GOVERNMENT OF SIKKIM
FORESTS AND ENVIRONMENT DEPARTMENT
FOREST SECRETARIAT, DEORALI, GANGTOK-737 102
Email: fca.sikkim@gmail.com

Sub: Proposal for diversion of 0.4908 Ha of Forest Land for construction of Rural Connectivity Road from Sakyong PWD to Tinek Chisopani Dokey Gaon in East District of Sikkim by Rural Dev. Department, Govt. of Sikkim – Addl. information reg.

Proposal No. : FP/SK/ROAD/38739/2019

Sub: Proposal for diversion of 0.4908 ha of forest land in favour of Rural Mangement and Development Department for construction of rural connectivity road from Sakyong PWD Road to Tinek Chisopani Dokey Gaon in East District of Sikkim -Additional Information -reg.

SITE PLAN FOR MUCK DISPOSAL

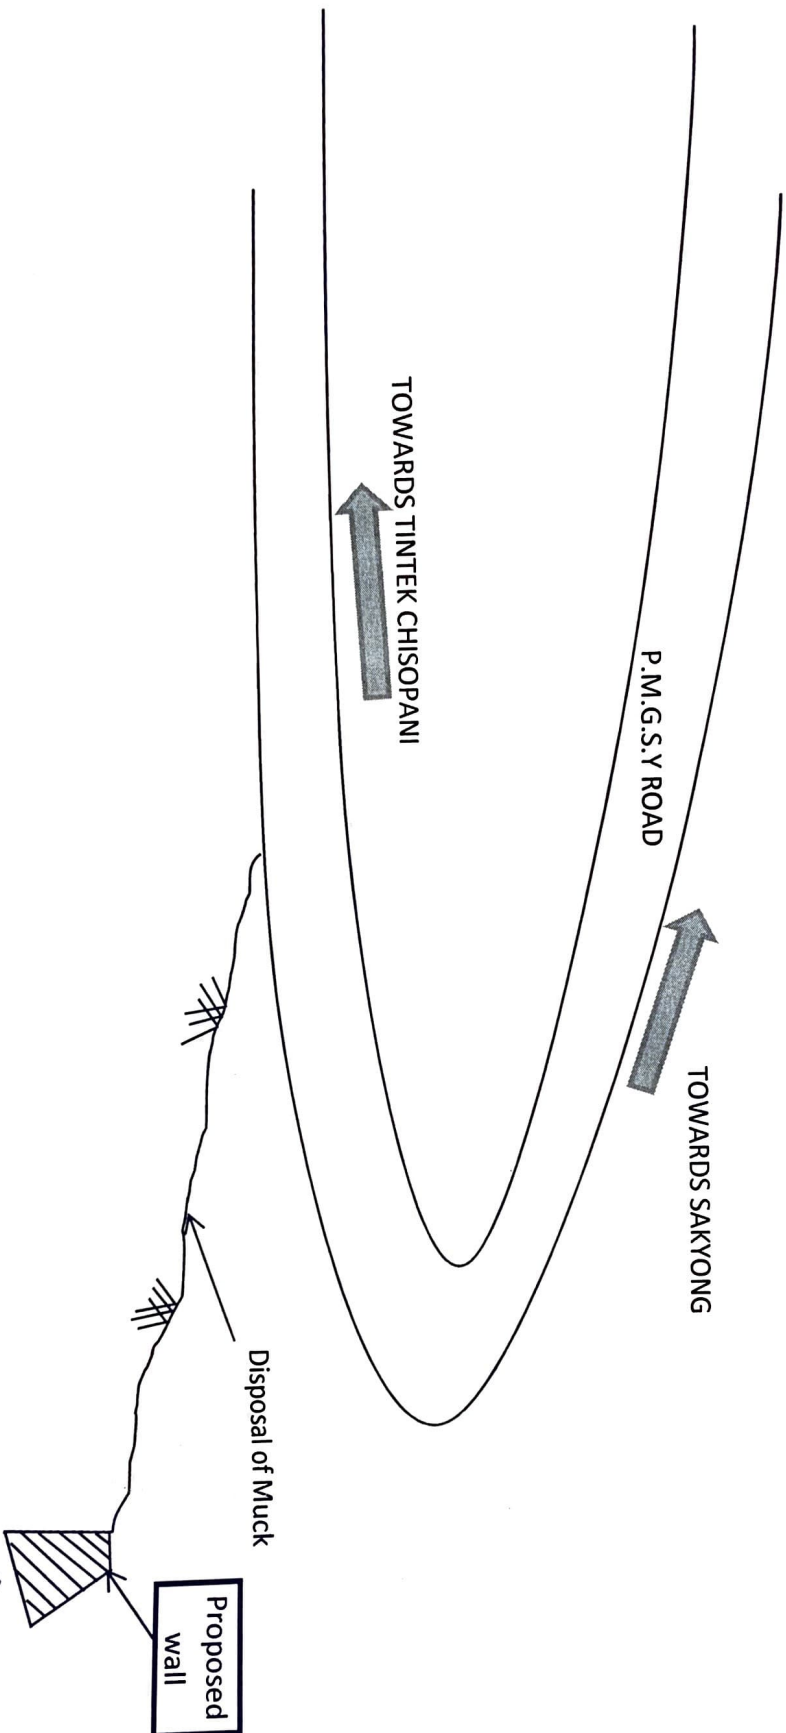
4.	The proposed diversion area is near to river. Therefore, quantity of Muck to be generated with GPS coordinates of muck disposal area/ Muck disposal plan and distance from river area is to be submitted.	As reported by the user agency quantity of muck to be generated along with GPS coordinates of muck disposal area/Muck disposal plan is submitted and uploaded on Parivesh Portal.

Sl No.	Name of Dumping Site	Location of Dumping Site	Area of Dumping Site (in Ha)	Volume of muck to be dumped (in cum)
1	Tinek	Lat. 27.1430° Long. 88.3002°	0.3960	17668.76
